WILLIAMSON COUNTY, TEXAS

CHANGE ORDER NUMBER: 2

Project:	<u>1604-068</u>
Roadway:	<u>Forest North Drainage Ph 1</u>
CSJ Number:	_____

**Forest North
Williamson County Project No. 1604-068**

SHEET
C-114
17 of 82

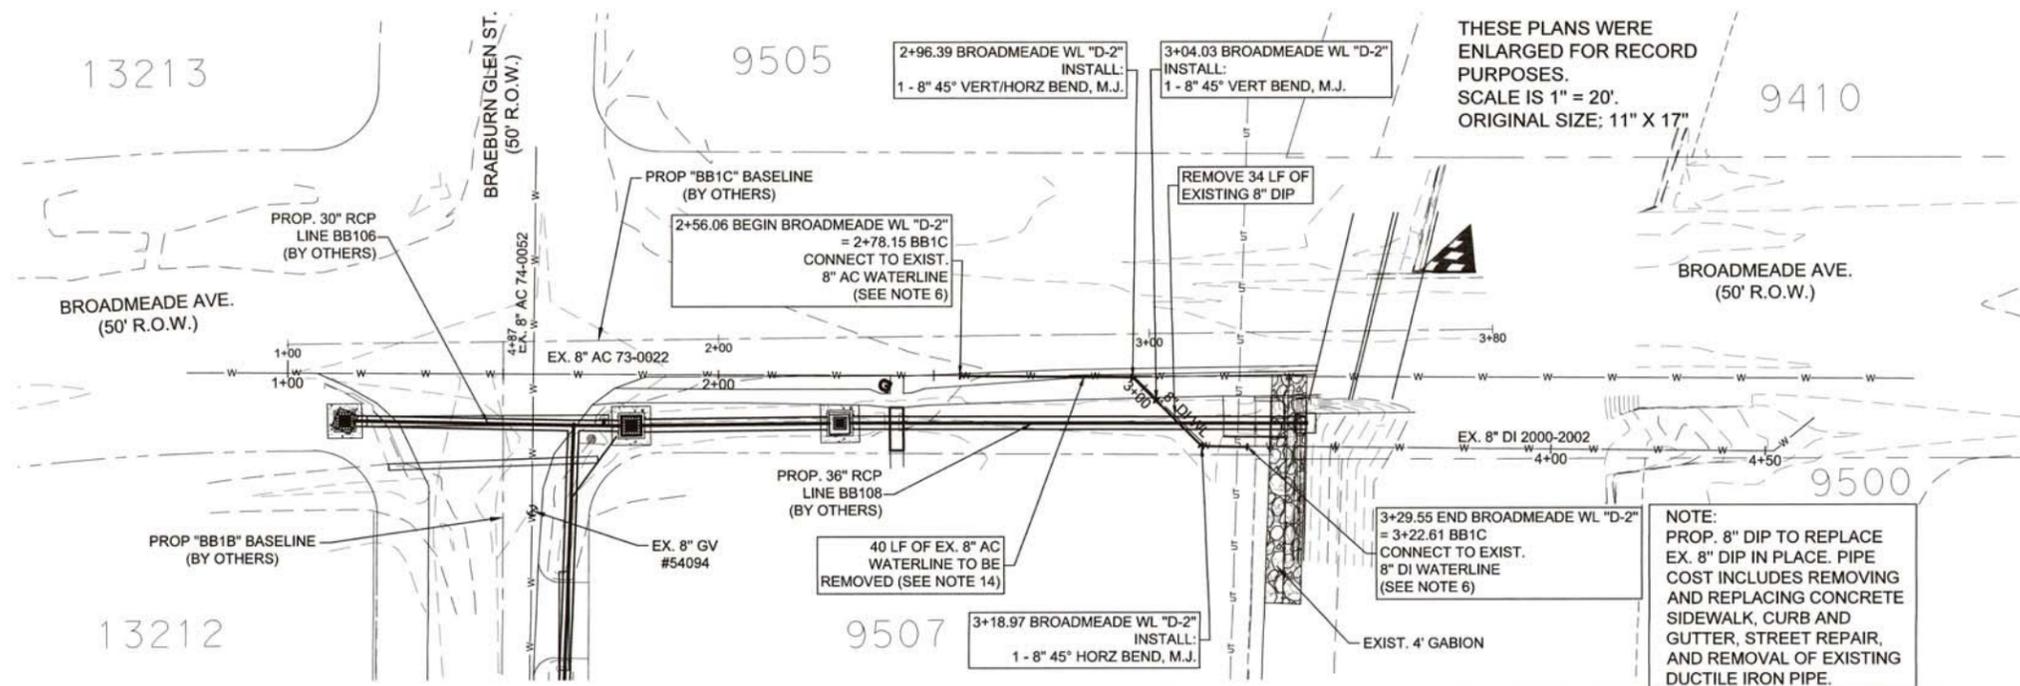
2G: Differing Site Conditions (unforseeable). Unadjusted utility (unforseeable). This Change Order compensates the Contractor for the removal and relocation of an existing waterline that is in conflict with the proposed storm sewer line BB1 at the corner of Broadmeade Avenue and Braeburn Glen. **4B: Third Party Accommodation. Third party requested work.** This change order also compensates the Contractor for completed trench repair of the asbestos line that is being removed. A portion of the trench repair quantity has been added to this change order. The remaining quantity will be added to a future change order. The City of Austin has agreed to compensate the Contractor for these costs.

This Change Order compensates the Contractor to remove and relocate an existing waterline that is in conflict with proposed storm sewer line BB1. The conflict is located near the corner of Broadmeade Avenue and Braeburn Glen. The existing waterline was not shown on the City of Austin waterline plans and therefore was not located by the One-Call services, prior to the storm sewer installation. The Contractor has agreed to extend existing bid items to pay for this work and has requested additional pay items with daily rates for de-watering the trench and required traffic control.

- Work to be performed in accordance with Items: See attached.
- New or revised plan sheet(s) are attached and numbered: C-114, C-122A
- New Special Provisions/Specifications to the contract are attached: Yes No
- New Special Provisions to Item N/A No. N/A, Special Specification Item N/A are attached.
